SUBJECT: SEQUOYAH NUCLEAR PLANT, UNITS 1 AND 2 - ISSUANCE OF
AMENDMENTS REGARDING ENHANCEMENT OF REACTOR COOLANT
LEAKAGE DETECTION AND OPERATIONAL LEAKAGE CONSISTENT WITH
STANDARD TECHNICAL SPECIFICATIONS (TAC NOS. MA6760 AND MA6761)
(TS 98-10)

The Commission has issued the enclosed Amendment No. 259 to Facility Operating License No. DPR-77 and Amendment No. 250 to Facility Operating License No. DPR-79 for the Sequoyah Nuclear Plant, Units 1 and 2, respectively. These amendments are in response to your application dated June 30, 1999, as supplemented June 16, 2000, and August 3, 2000, which requested approval to update the current Technical Specification (TS) requirements, and appropriate TS Bases sections for reactor coolant system (RCS) leakage detection and RCS operational leakage specifications consistent with the Improved Westinghouse Standard TS (NUREG-1431). The U.S. Nuclear Regulatory Commission staff has reviewed and approved your request.

By letter dated June 30, 1999, as supplemented June 16, 2000, and August 3, 2000, the Tennessee Valley Authority (TVA, licensee) proposed a license amendment to change the Technical Specification (TS) for the Sequoyah Nuclear Plant (SQ

FIGURE 3.5.6-1
Seal Injection Flow Limits

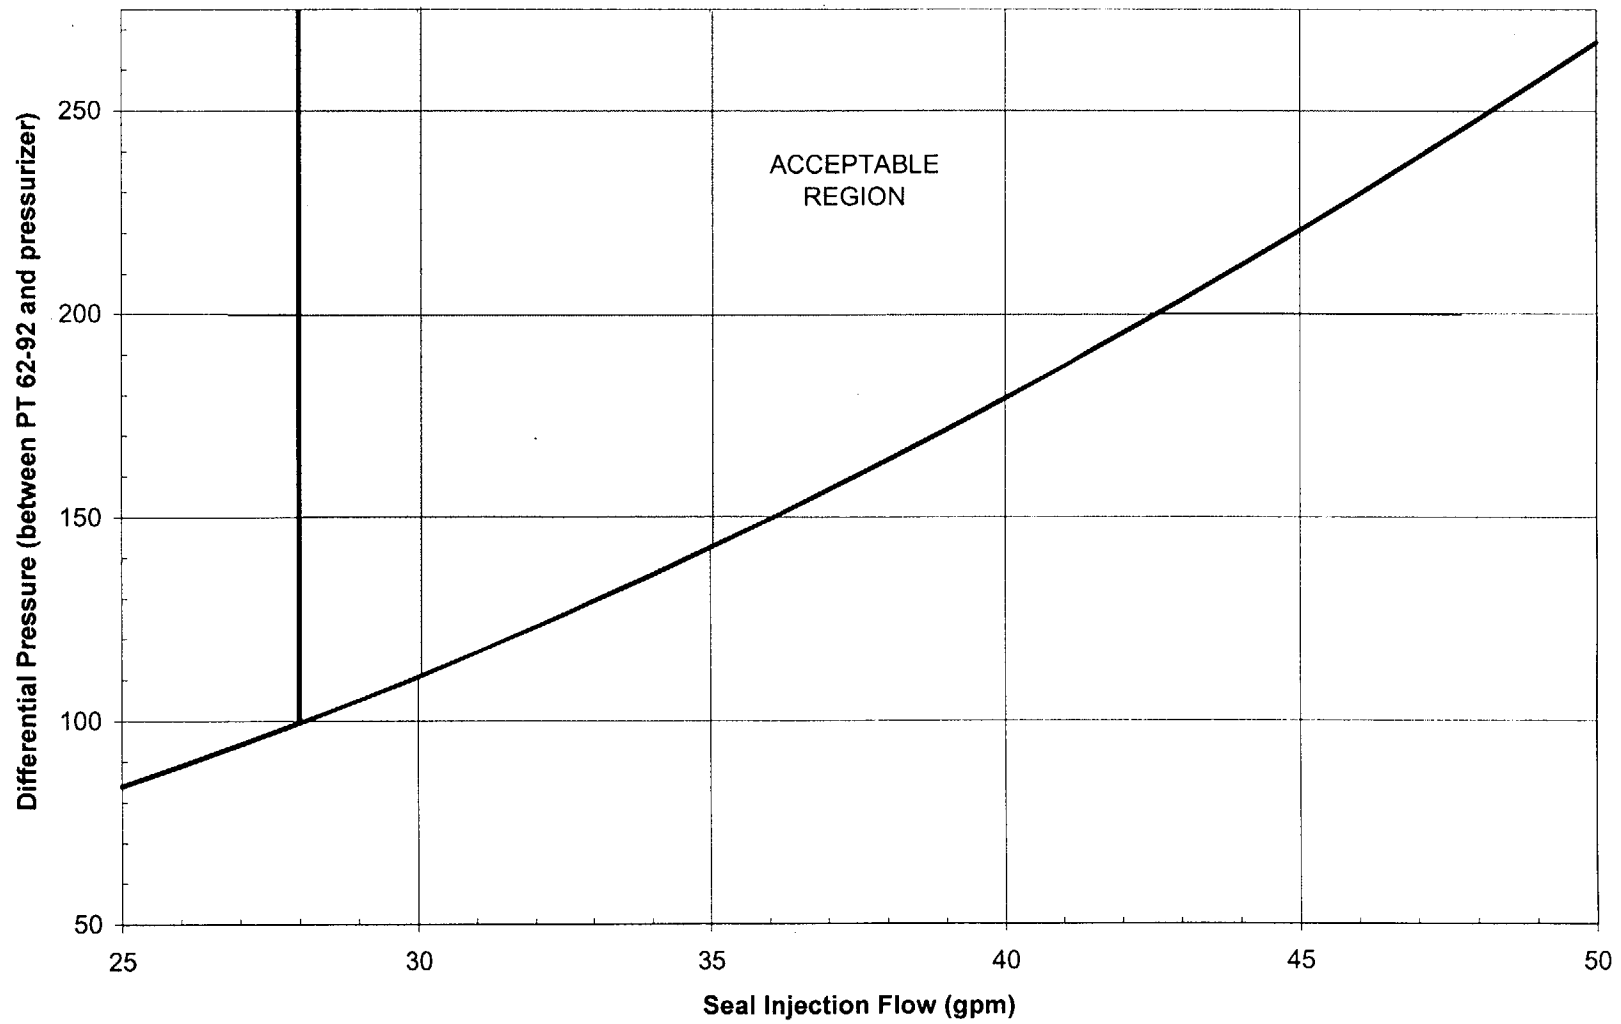
New TS 3.5.6 is being added to provide the requirements for the seal injection flow. This specification takes the place of the current requirements in the operational leakage specification for controlled leakage. The new specification is fashioned after NUREG-1431; however, a modification to the NUREG has been incorporated that utilizes a relationship involving the pressure differential between the charging pump discharge header and the RCS and total seal injection flow. This method for determining acceptable seal injection flows does not require the current provision to have the modulating valve fully open in consideration of the SQN design for the location of the header pressure sensor. The current flow limit of 40 gpm at normal RCS pressure is replaced by range of flow limits that correspond to this amount of flow restriction over various amounts of pressure differential between the header and the RCS.

The surveillance for Specification 3.5.6 will utilize this range of differential pressures and associated flow values to verify acceptable settings of the seal injection throttle valves. The figure that contains these relationships will be included in the new specification. A footnote, consistent with NUREG-1431, has been added to the surveillance that clarifies the need to be at normal RCS pressure and stabilized for 4 hours prior to the performance of the flow verification. This provision replaces the existing exception for Specification 4.0.4. This specification will apply in Modes 1, 2, and 3, which is a modification of the current requirement that includes Mode 4. As a result of this change, the action will only require a shutdown to Mode 4 within a total of 12 hours if inoperable seal injection flows cannot be corrected.

The staff has reviewed the proposed RCP seal injection flow limits (Figure 3.5.6-1) and concludes that these limits would provide a more conservative level of protection with respect to ECCS performance since they are developed based on the current TS value at normal operating RCS pressure. The staff has also reviewed the proposed TS 3.5.6 for RCP seal injection flow and concluded that the proposed changes are consistent with NUREG-1431, including the recommended allowable action times and surveillance intervals. The current TS requirements do not prescribe sufficient parameters to ensure that appropriate conditions are established to verify the seal injection flow resistance. The proposed revision will enhance this SR by establishing an RCP seal injection flow limit based upon the differential pressure between the charging header and the RCS. The associated SR (4.5.6) requires flow rate verification every 31 days to ensure that flow rate is within ECCS safety analysis limits. Hence the TS requirements will continue to maintain ECCS performance within the envelope of the safety analysis. Therefore, this change is acceptable because the current limits for RCP seal injection flow will continue to be maintained in accordance with existing requirements based on the safety analyses and plant operating procedures.
